Guide to NMA

Winchester Avenue, Blaby, Leicester LE8 4GZ

New industrial units for

A: Initial Issue 11/02/24

2.1.3 Below is an excerpt from the approved drawings.

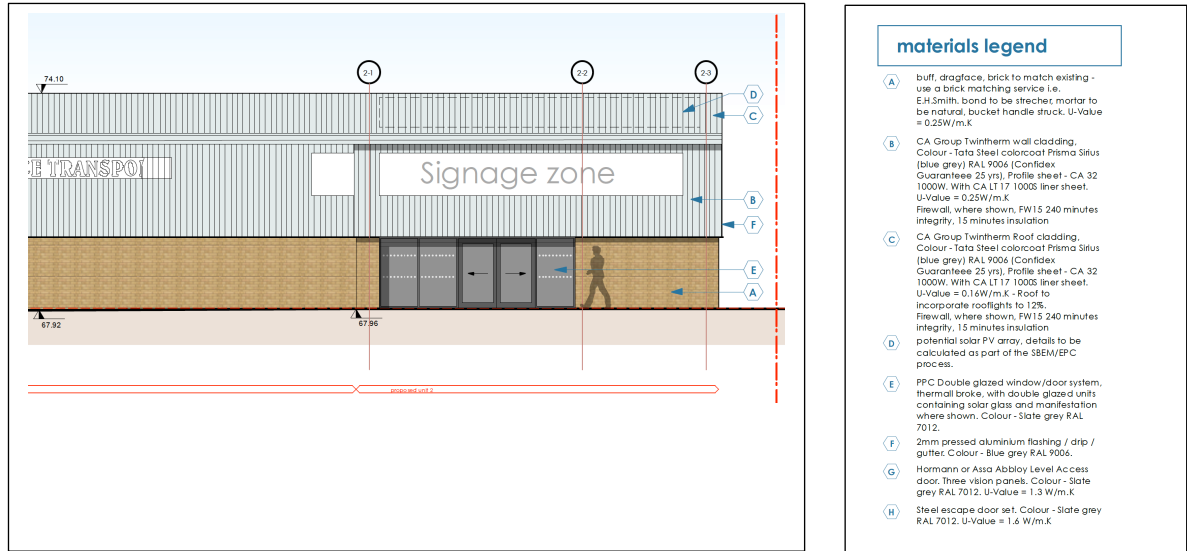
2.1.2 The above approved drawings state the cladding material as – Prisma Sirius (blue Grey) RAL 9006, CA Group Twin Therm profiled sheet CA 32 1000W.

2.2.1 The cladding is proposed to change from the approved to – Tata Steel Trisomet composite panel, coloured RAL 7038 Agate Grey

2.2.2 Drawings have been amended to REVISION B:

- Unit 2 Elevations - Dr No - 21-119-B002B
- Units 3 and 4 Elevations - Dr No - 21-119-B021B

3.1.2 The approved drawings showed a double glazed curtain walling:

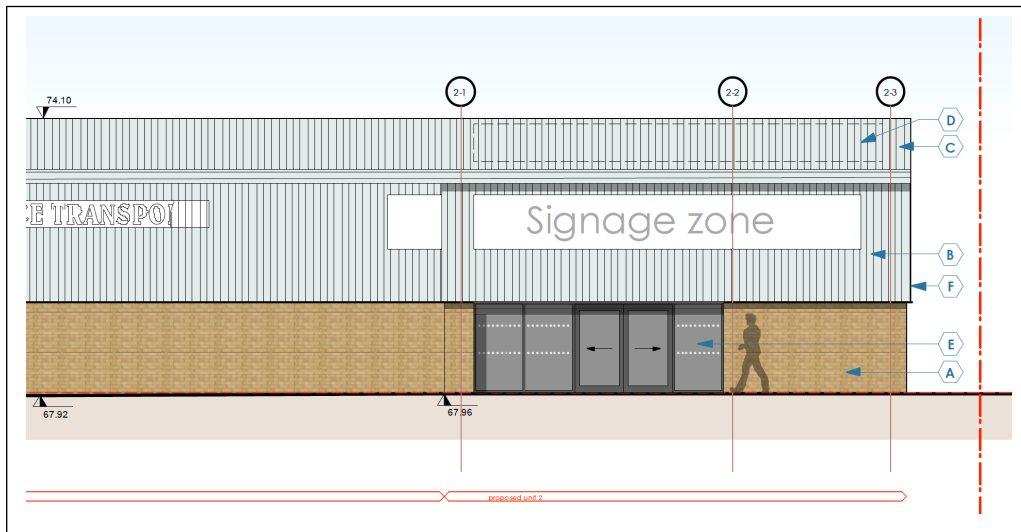
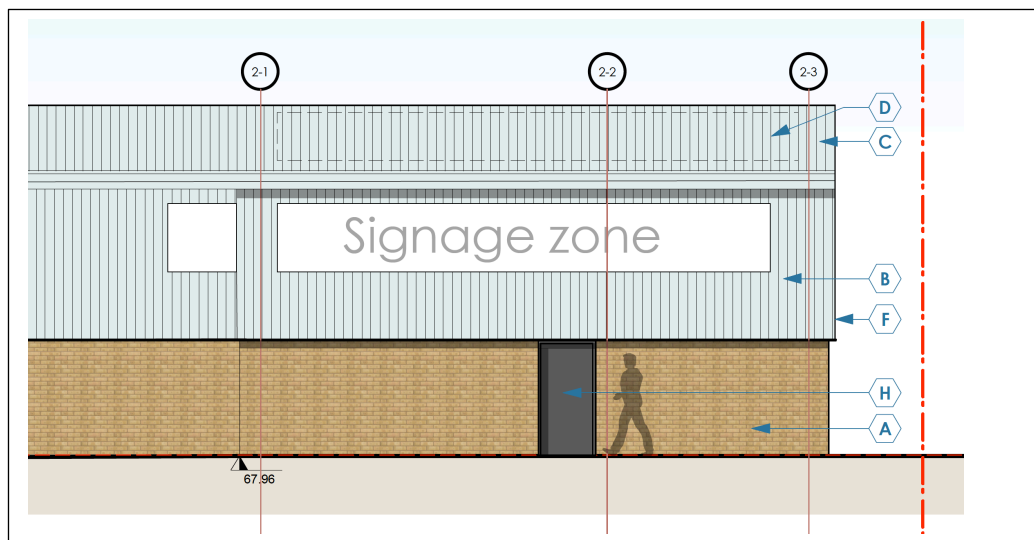
3.1.1 The planning approval detailed Unit 2 entrance doorway on approved drawings:

3.2.1 The proposed drawings detail Unit 2 entrance doorway as a steel security door to match the other approved units, on approved drawings:

- Unit 2 Elevations - Dr No - 21-119-B002B
- Unit 2 GND Plan - Dr No - 21-119-B001B

3.2.2 The proposed drawings show a single steel door set:

- 4.1.1 The planning approval detailed Unit 3 and 4 rear elevation (facing the railway line) on approved drawings:
- *Units 3 and 4 Elevations - Dr No - 21-119-B021A*
- 4.1.2 The elevation has been approved with brickwork to match the existing Unit 1 and the new three units.

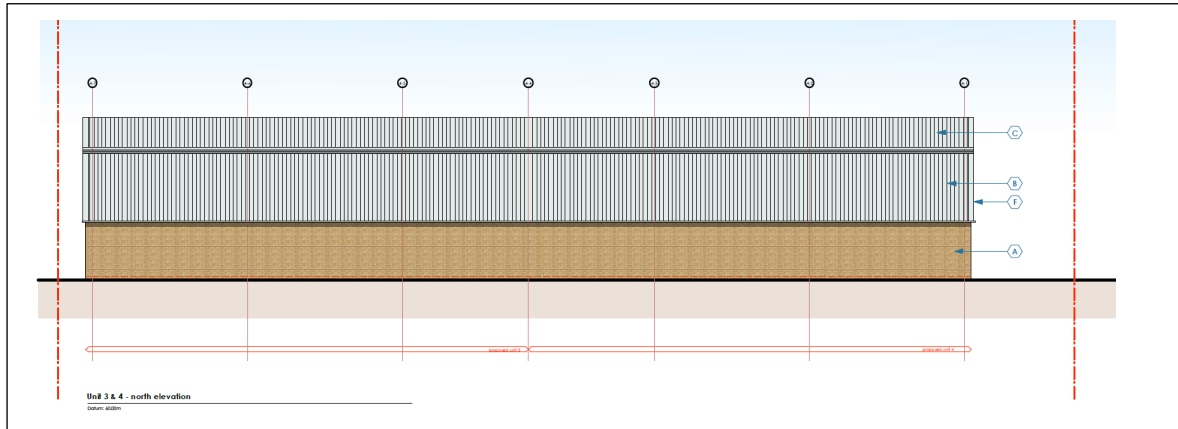
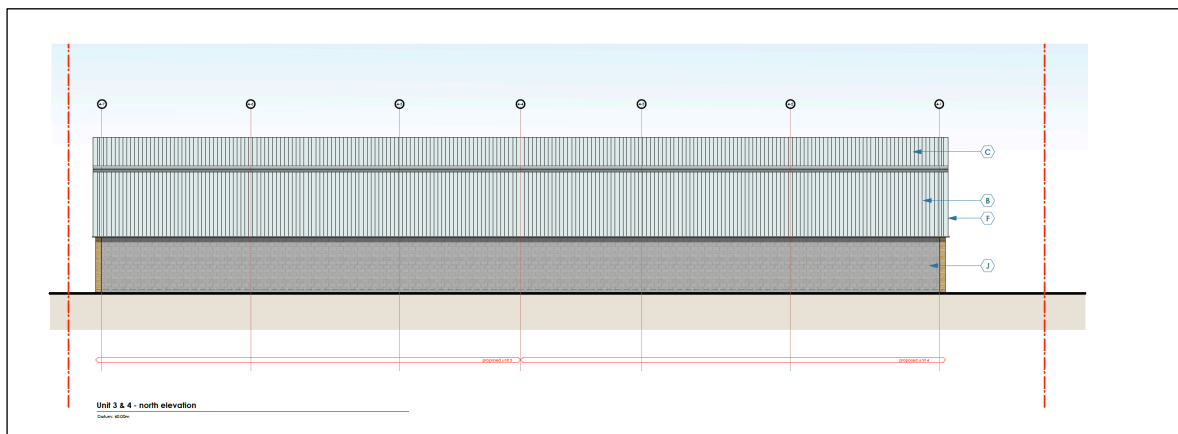
- 4.2.1 The brickwork is proposed to change from the approved brickwork to – fareface blockwork on the rear elevation only.
- 4.2.2 Drawings have been amended to REVISION B:
- *Units 3 and 4 Elevations - Dr No - 21-119-B021B*
